**ADDENDUM #1**  
 June 15, 2023

**TO: ALL Prospective Bidders**  
**PROJECT NAME: GPI Effluent Sewer Realignment**  
**BID REFERENCE #: 91345-004.0**  
**BID DUE/OPENING DATE: Tuesday, June 27, 2023 at 3:30 p.m. Local Time (ET)**

**JONES & HENRY ENGINEERS ADDENDUM  
01**

**GPI EFFLUENT SEWER REALIGNMENT**

**ST-2.1**

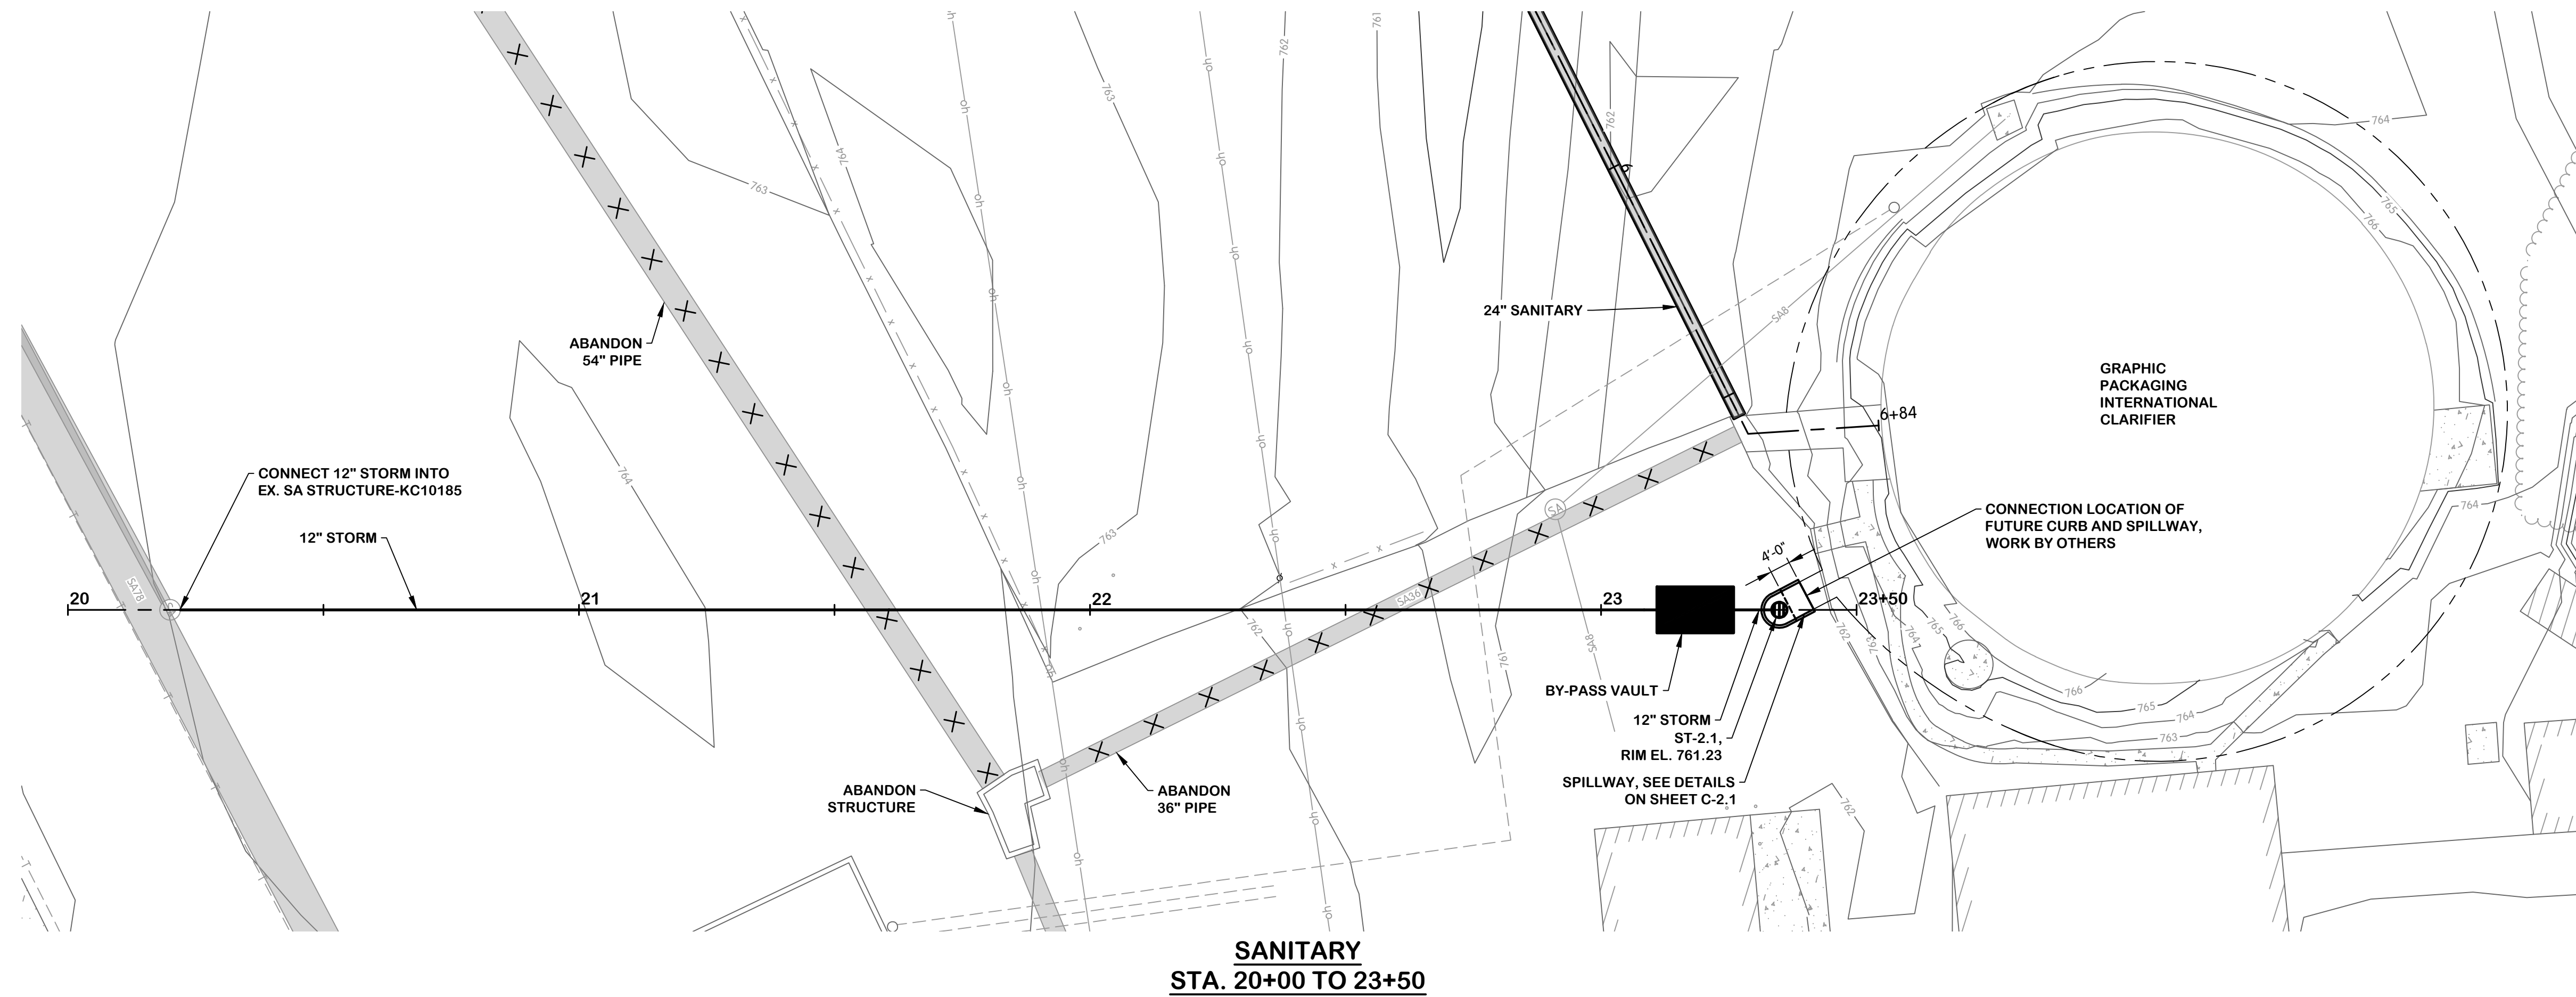
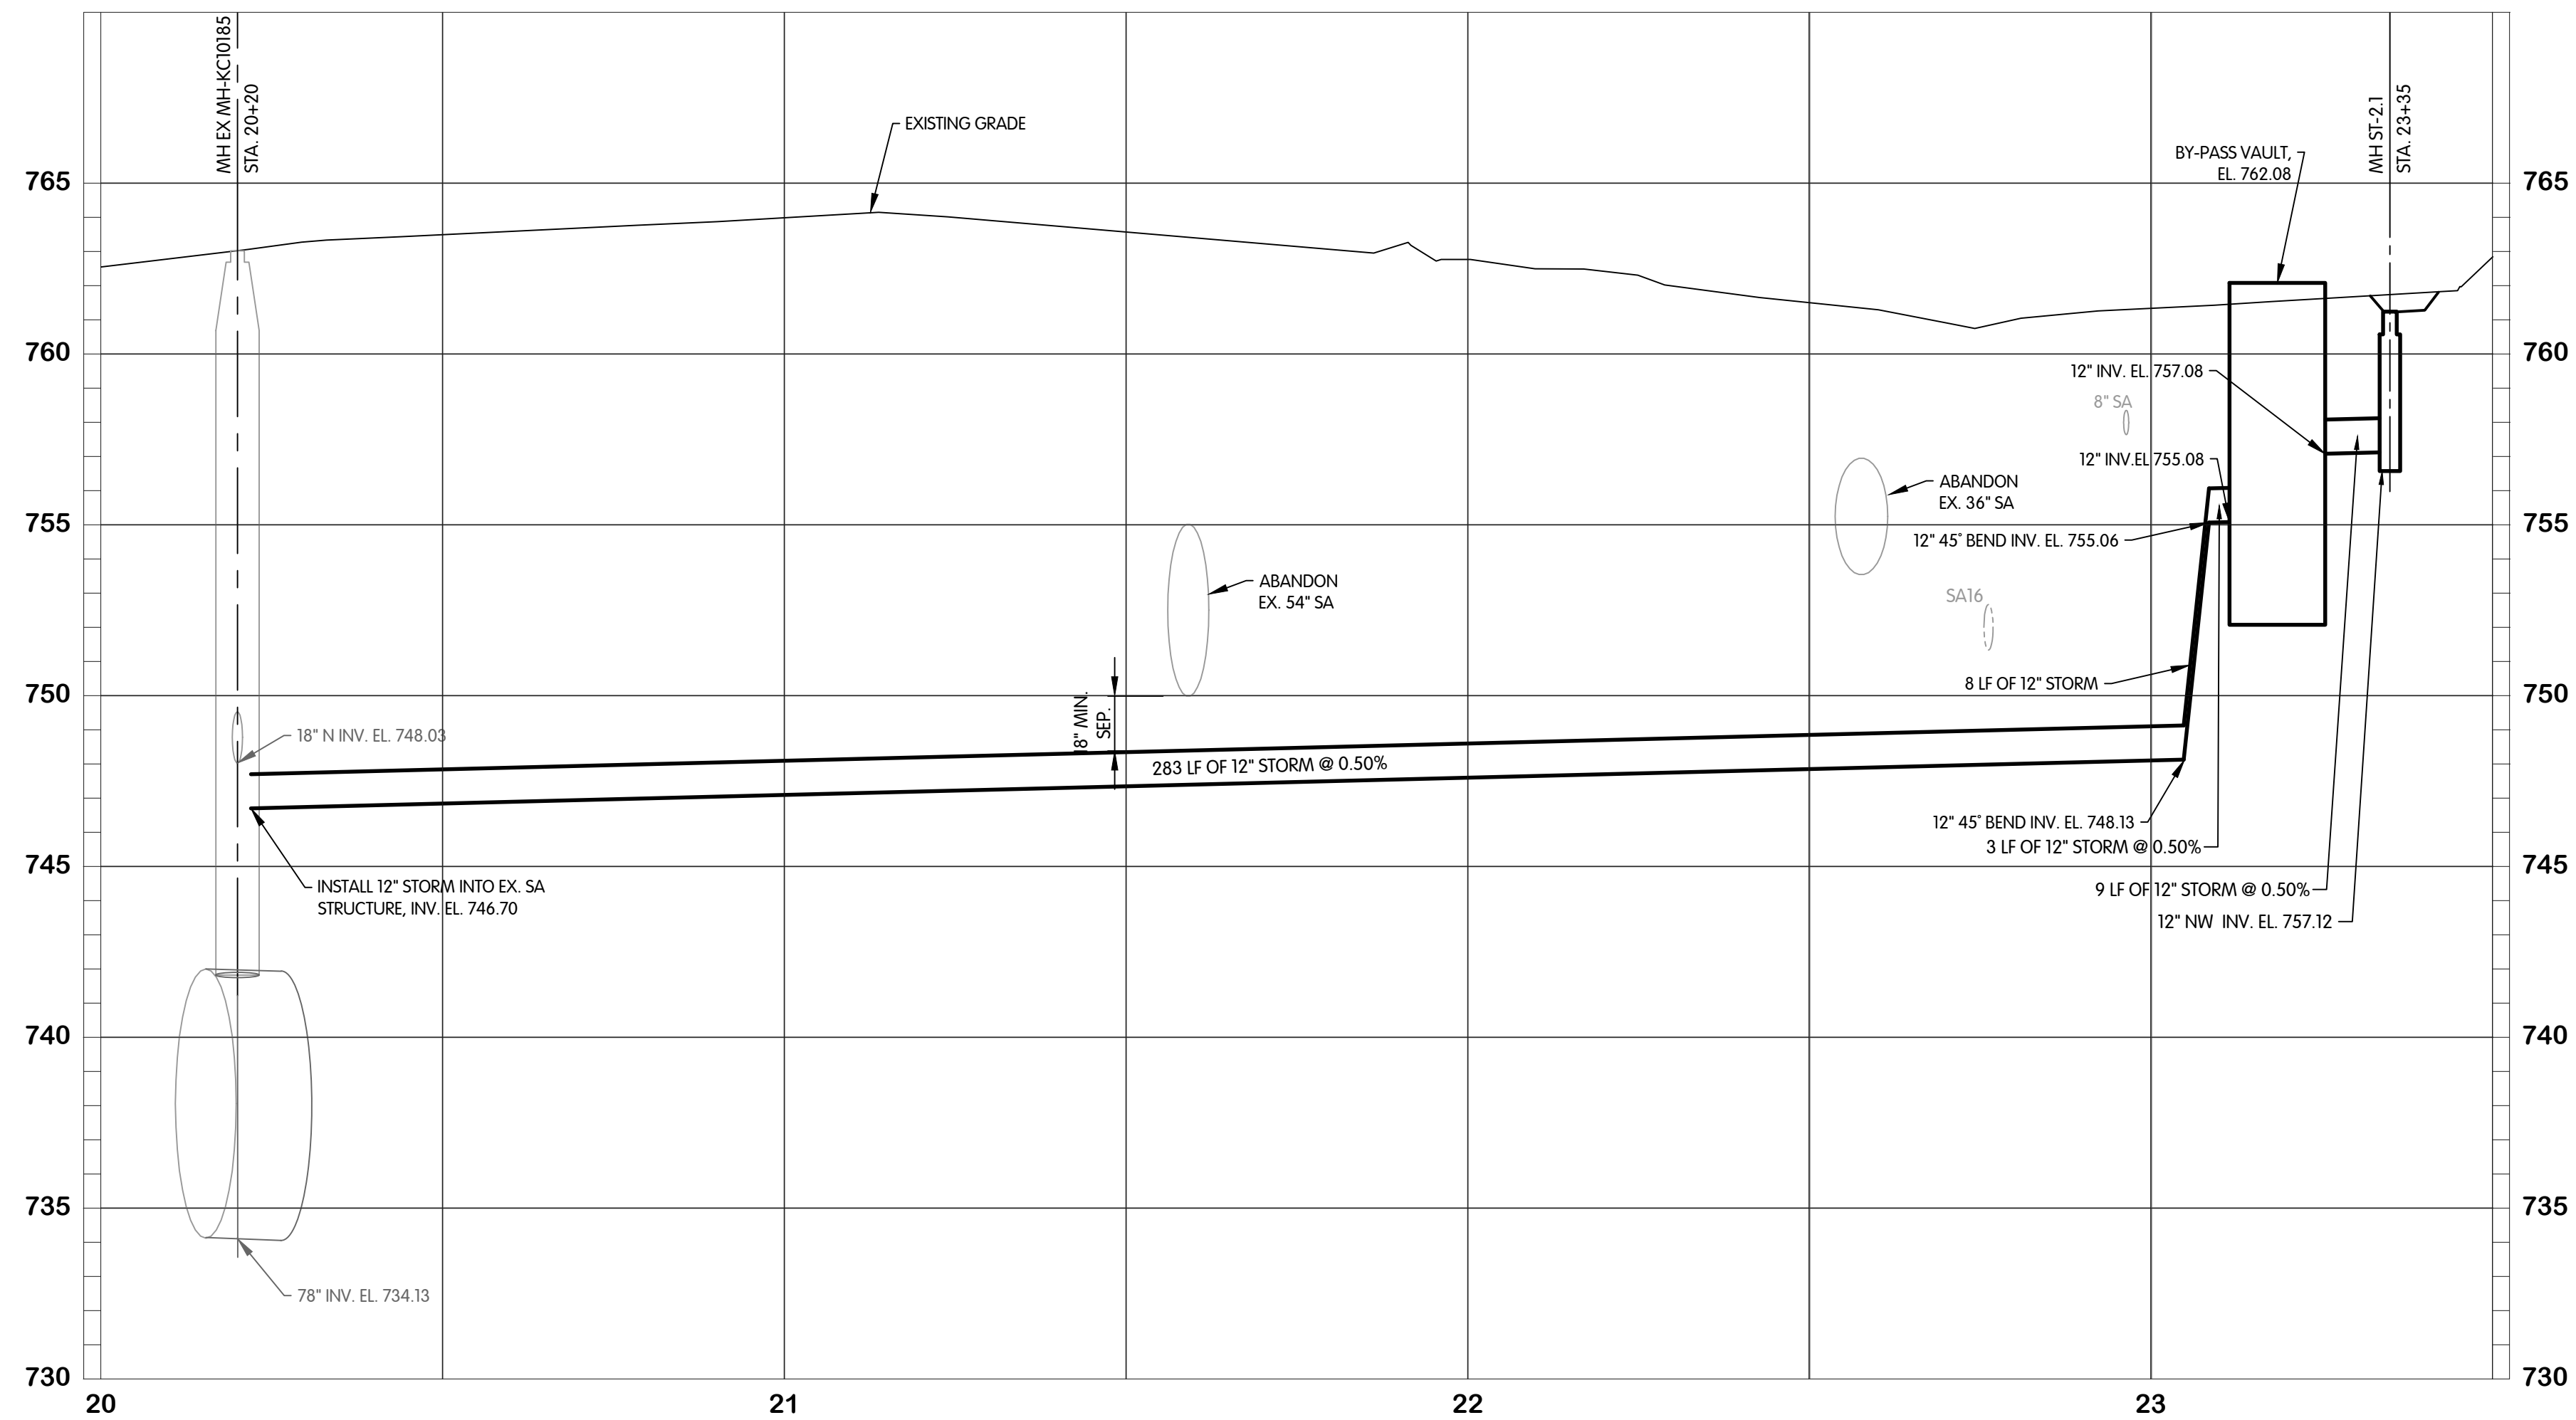
Additional storm sewer work, concrete spillway and By-Pass Vault is included in Addendum 01.

C-2.1, ST-2.1
